Amendment No. 2

Generation Interconnection Agreement

LCRA Transmission Services Corporation

FPL Energy Upton Wind I, LLC

Exhibit "C-2"
POINT OF INTERCONNECTION DIAGRAM

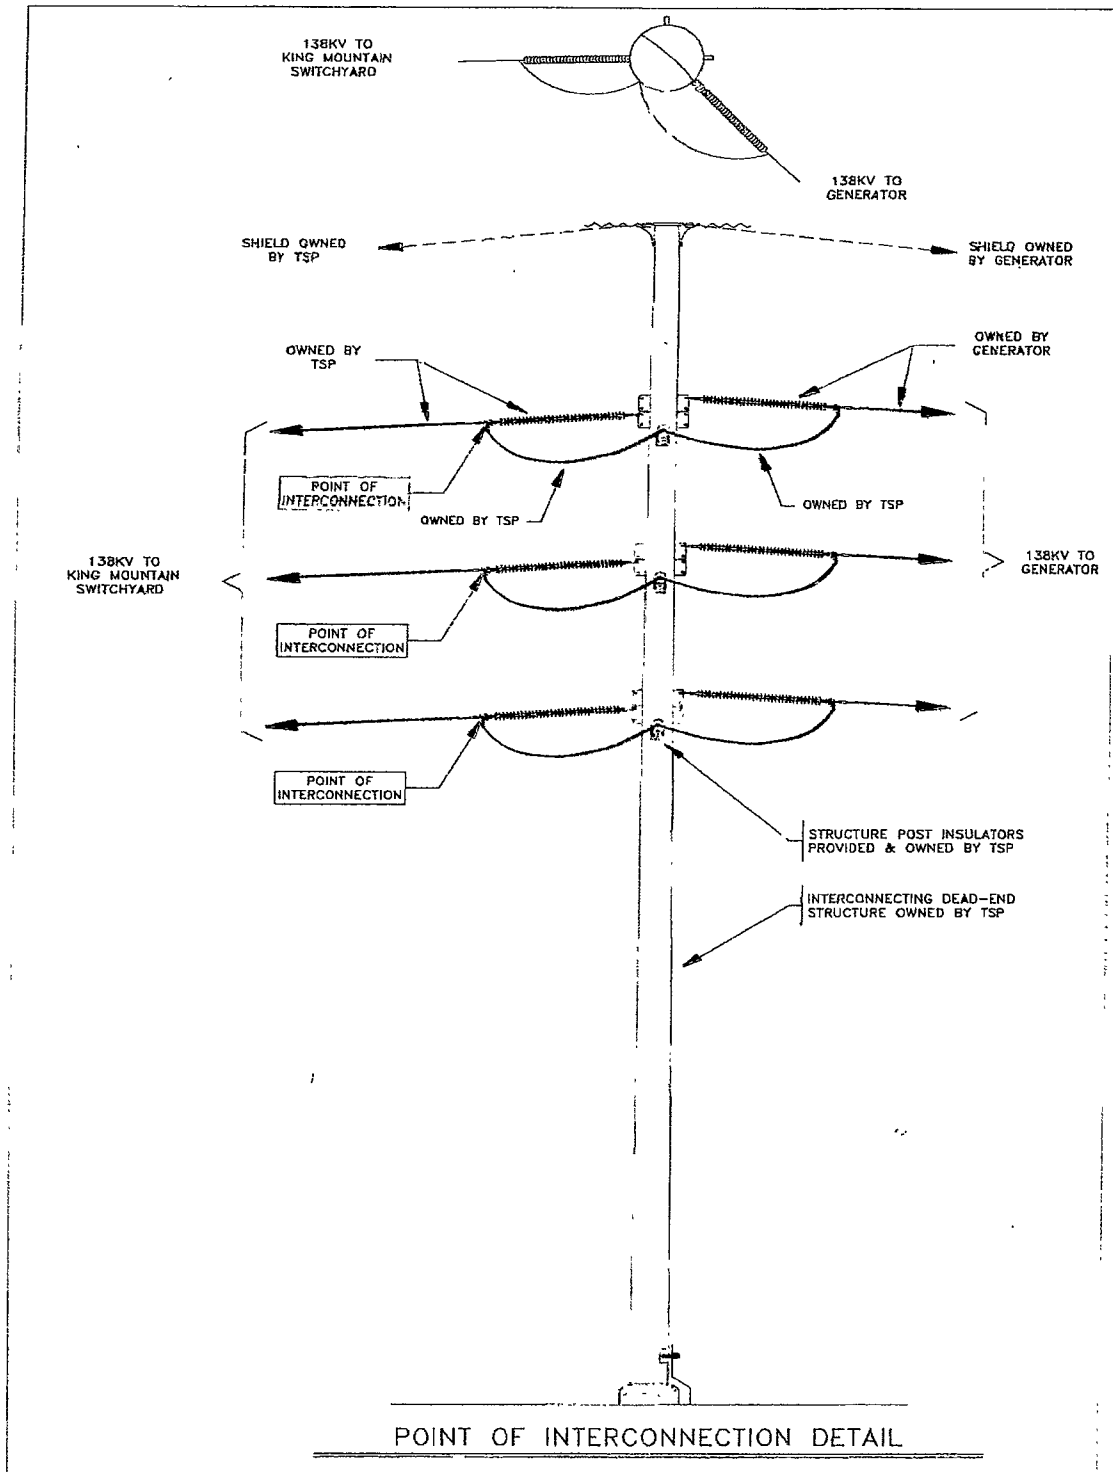
WHEREAS, this amendment to the Interconnection Agreement is necessary because the TSP will install 138-kV circuit breakers to increase transmission service reliability at the King Mountain Switchyard and the description of the LCRA TSC Transmission Interconnection Facilities (TIF) requires updating; and

WHEREAS, the ERCOT Polled Settlement metering will be relocated from the plant to the TSP's new switchyard at King Mountain Switchyard.

1. Exhibit "C" Interconnection Details (including the diagrams Exhibit "C-1" and "C-2" attached thereto), attached to the agreement, is deleted in its entirety and Exhibit "C" Interconnection Details (including the diagrams attached thereto), attached to this Second Amendment, is hereby added to the Agreement in lieu thereof.

A). TSP's ERCOT polled settlement ("EPS") metering will be located at the TSP Switchyard as part of the TIF. Three 138-kV extended range, metering current transformers will be used to accurately read the generation energy and power delivered to the grid and the auxiliary energy and power consumed through the Point of Interconnection. Three 138-kV metering accuracy voltage transformers will also be installed by the TSP for the ERCOT settlement metering. The ERCOT settlement metering panel furnished by the TSP will be located in the TSP Switchyard.

- (c) Three (3) 145-kV, 3000A circuit breakers in a ring-bus configuration
- (d) Six (6) 138-kV, 3000A VAB switches
- (e) Nine (9) 138-kV coupling capacitor voltage transformers "CCVTs"
